**ADDENDUM No. 2**  
**Request for Competitive Sealed Proposals (CSP)**  
**19CSP104 Renovations at Dobie Middle School**

**Addendum No. 2**

**TO:** Prospective Bidders  
**FROM:** Haddon+Cowan Architects  
**SUBJECT:** AISD Dobie Middle School Renovations

**DATE:** February 15, 2019  
**HCA PROJ. NO:** 18-1032  
**AISD PROJ. NO:** 190035-DOBIE

**1 ENLARGED KITCHEN - PLUMBING DEMOLITION PLAN**  
 P1.2 1/4"=1'-0"

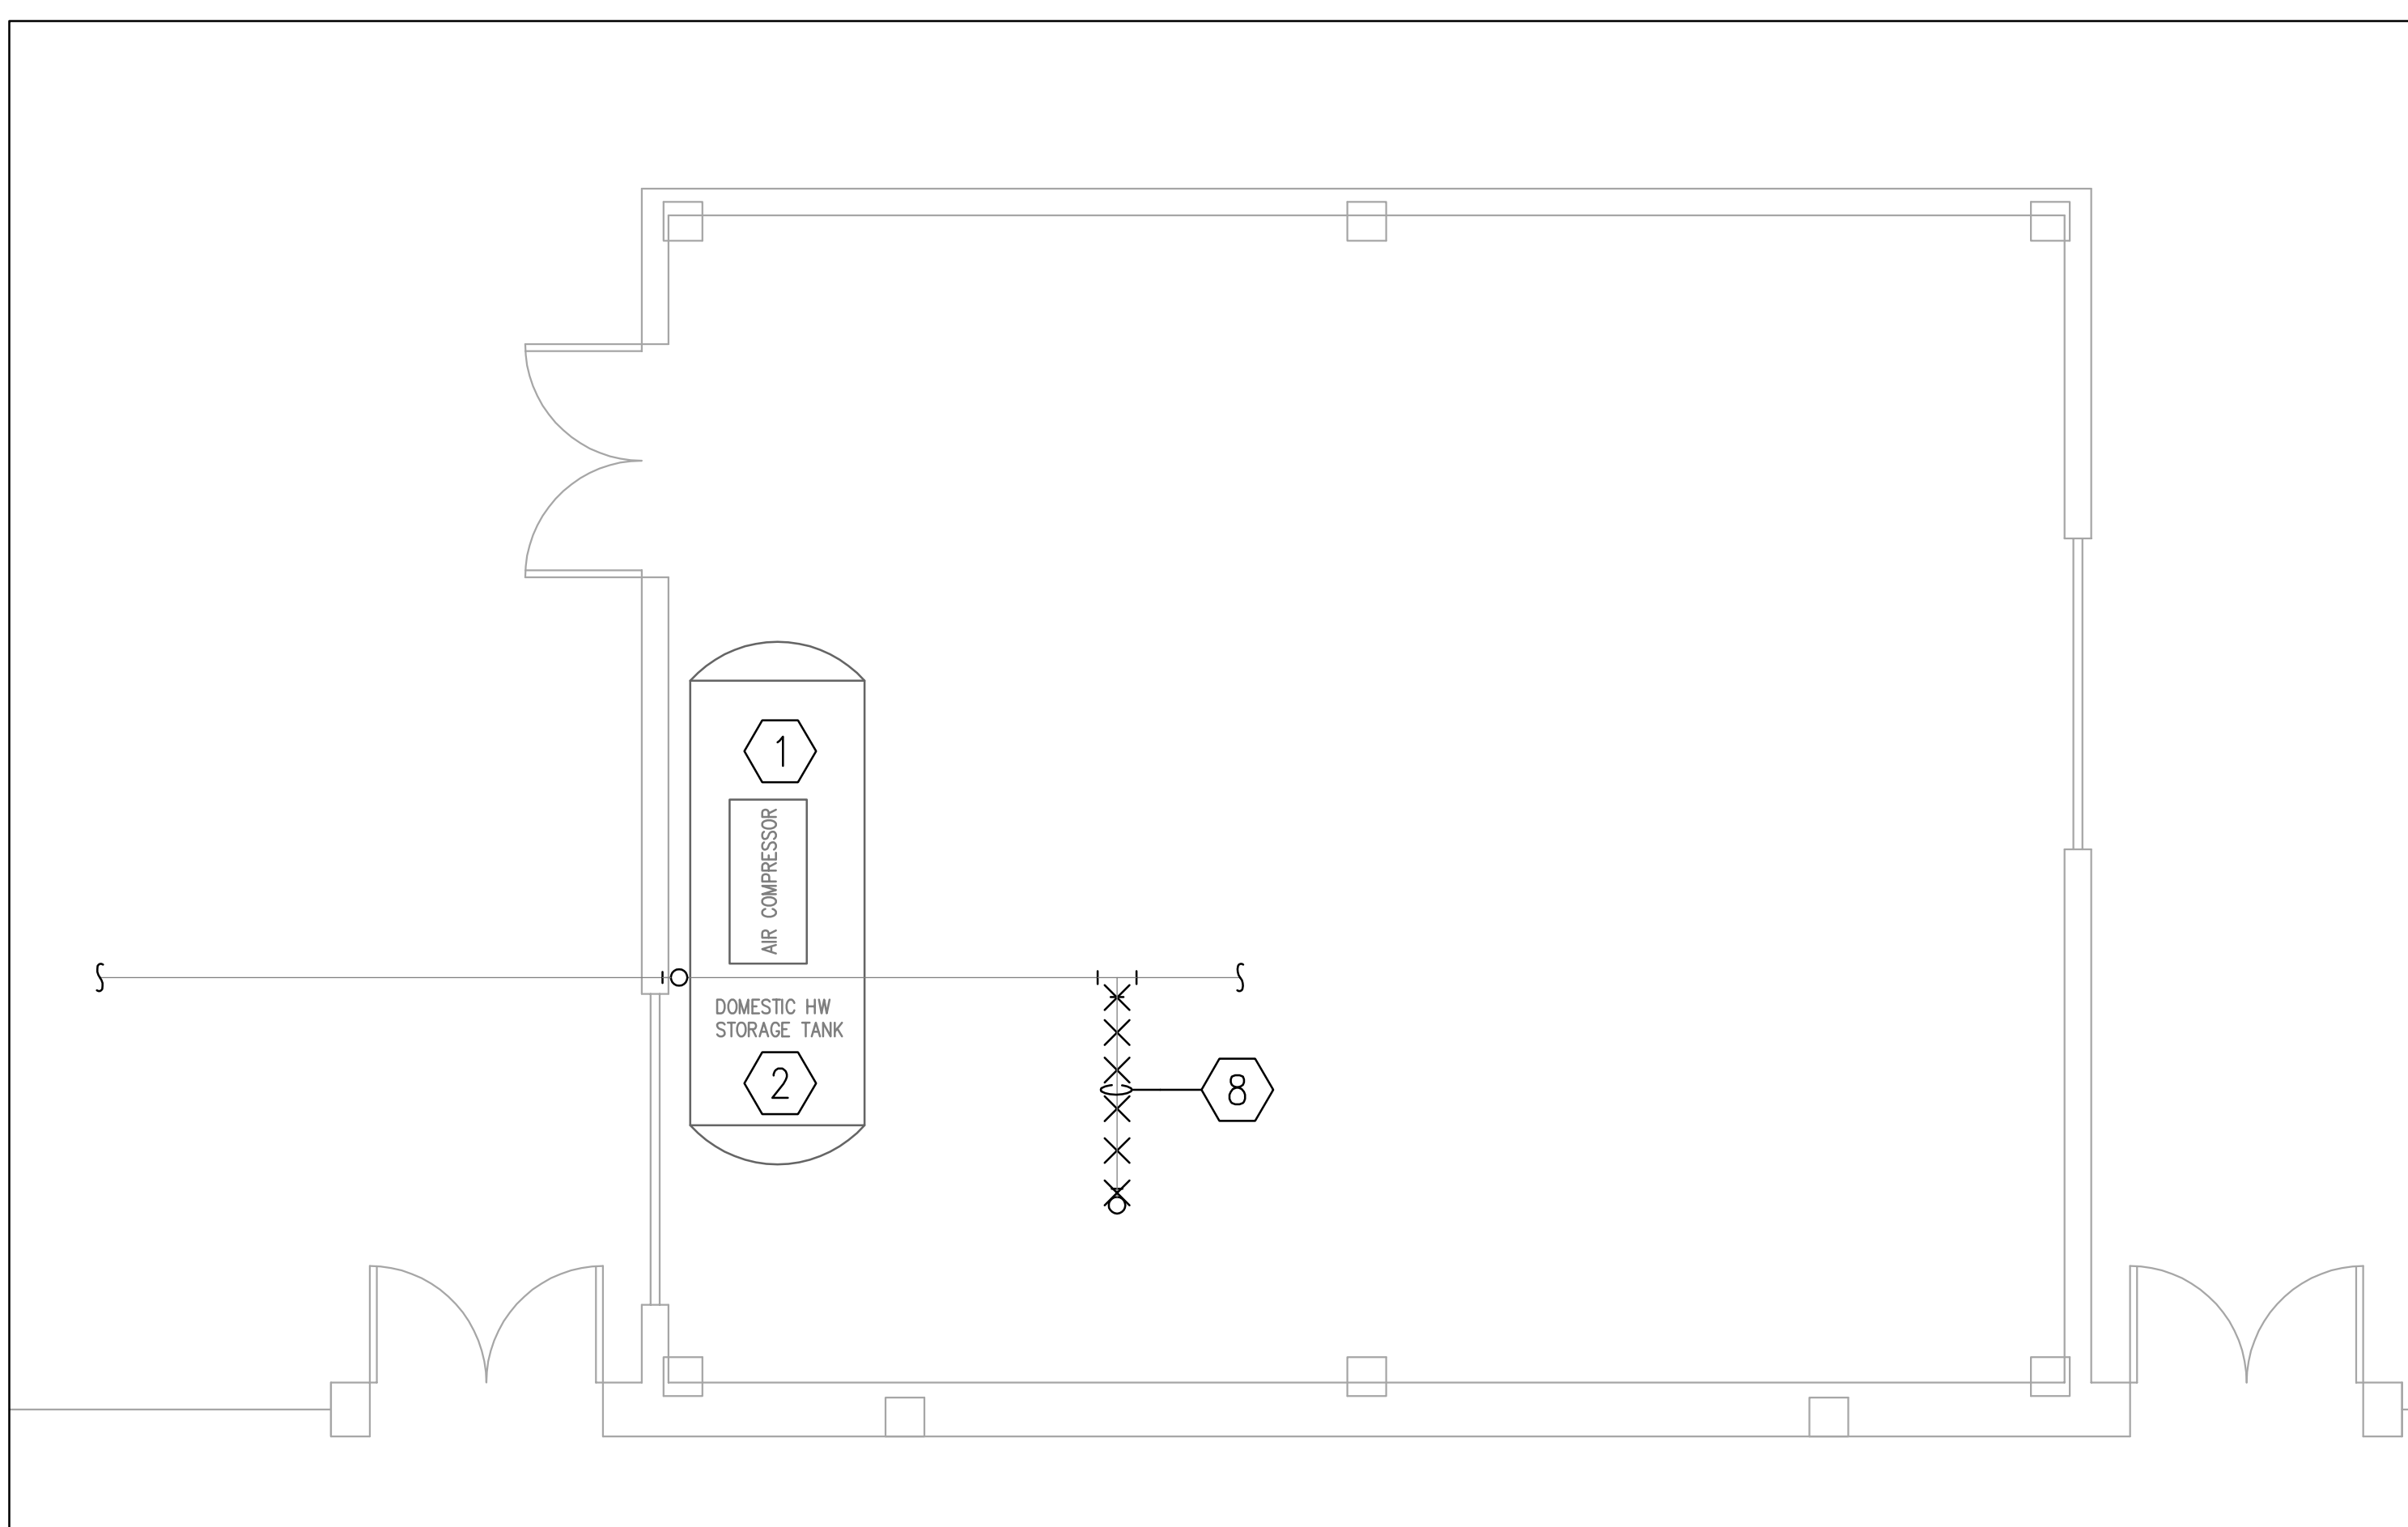
- a. Added keyed note to remove grease waste back to main.
  - b. Added keyed note to demolish sanitary waste line back to main.
17. Sheep P2.2 – Revised and Reissued
